FORD Ka steering racks (SR2709)

Application : Some Ford KA steering racks (SR2709) are supplied brand new from ERA Benelux. This to assure continuity of supply. They are sold at a “remanufactured” price. As a result the old – surcharged – unit can be injected in the remanufacturing chain.

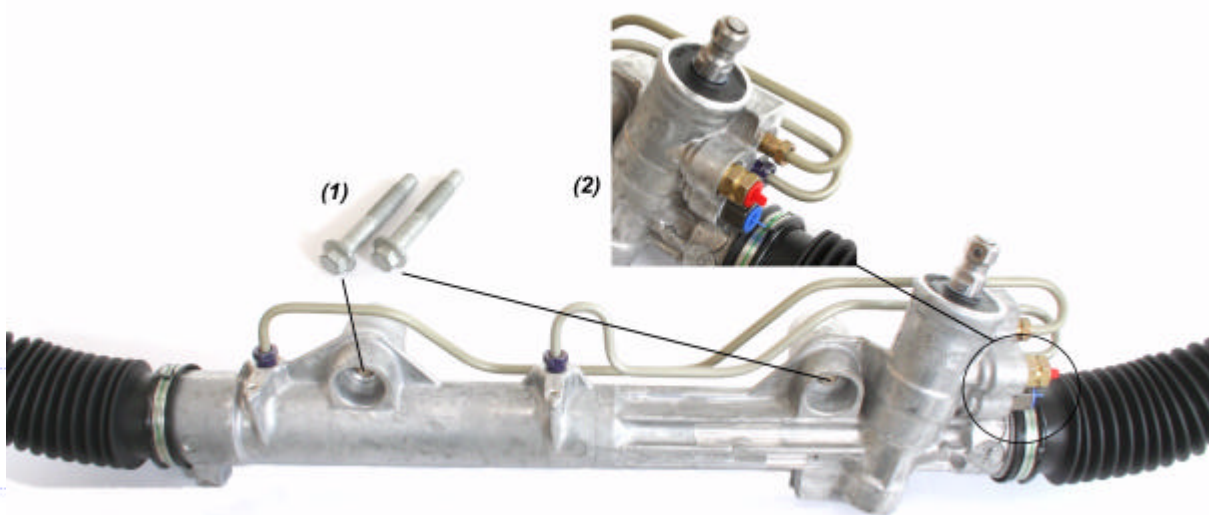
1. Unlike the older KA models these new generation KA racks are fitted “cold on cold”. The mounting bushes are no longer required. (The bolts to be used are supplied with the rack, see picture n° 1).
2. On the new racks both the check valve (you will find it in the high pressure port), as well as the inlet and outlet valves (see picture n°2) are premounted. These valves can be removed, because they are already fitted on the hoses of the old rack.

Note : When removing the inlet and outlet valves, please pay attention to the CHECK valve. It is a vital part in the steering system. Not fitting this check valve usually results in a leakage on top of the pinion housing. It is obvious that warranty is void if not applied.
